Retrofit to New Style Drench Hose Valve

When utilizing the updated valve design (launched in October 2011) on older style drench hoses, it is important to know that in most applications the valve is not a direct replacement. Please review the following information to determine how to best retrofit your drench hose.

Deck Mounted Type

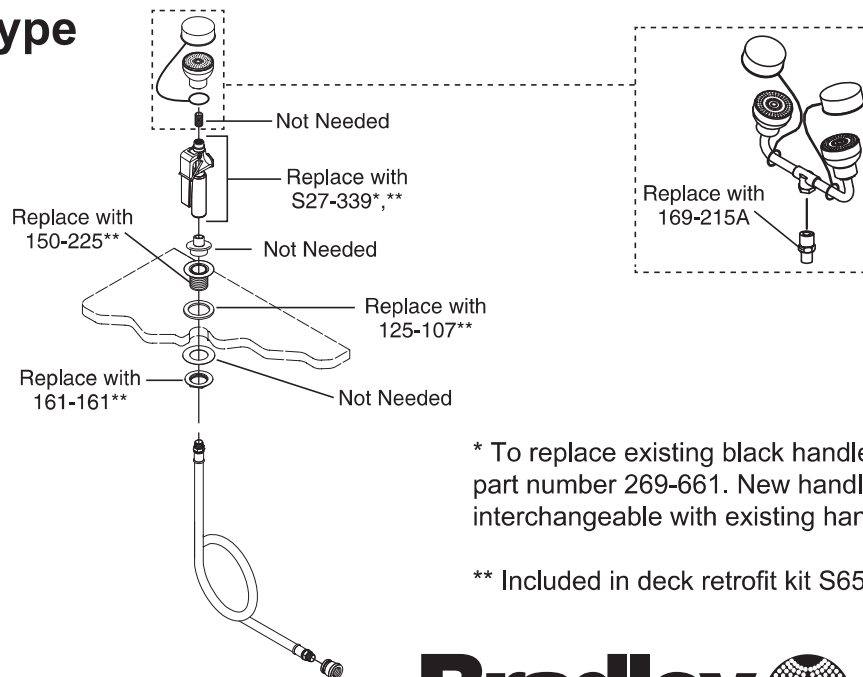
(Models S19-460, S19-460EFW, S19-465, and S19-465EFW)

New mounting components required for new valve style. To retrofit deck mounted type, order complete kit S65-381.

* To replace existing black handle only, order part number 269-661. New handle is not interchangeable with existing handle.

** Included in deck retrofit kit S65-381.

Wall Bracket Type II

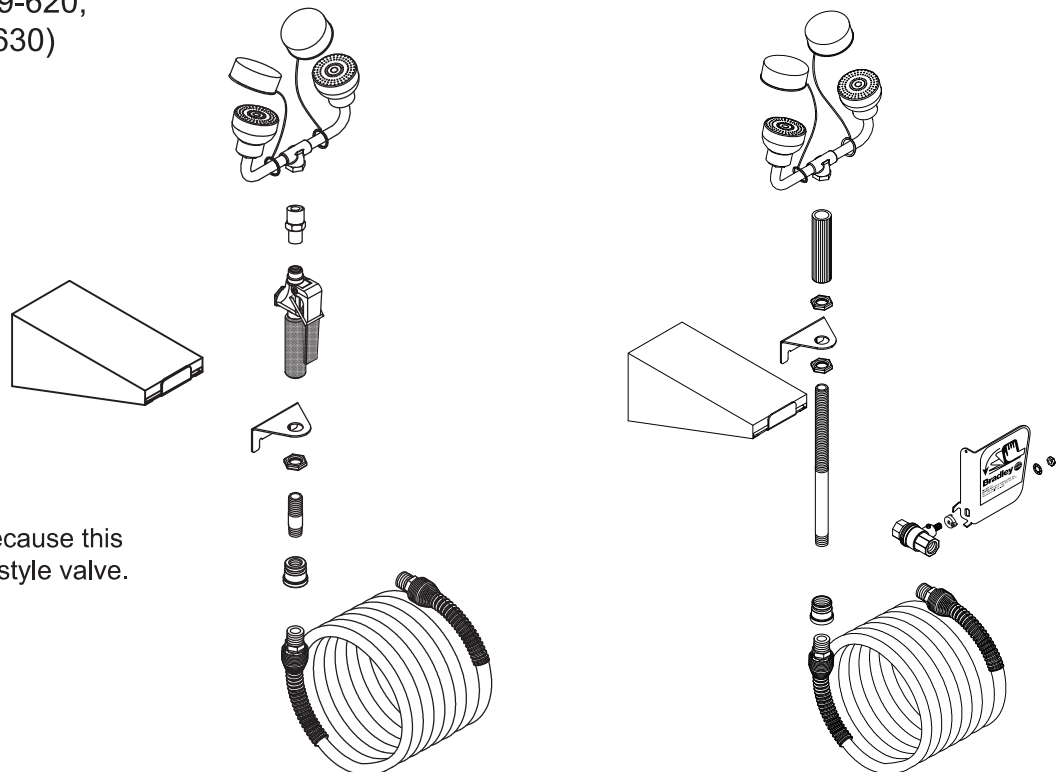
(Former Models S19-620, S19-625, and S19-630)

Must upgrade to new style because this bracket will not hold the new style valve.
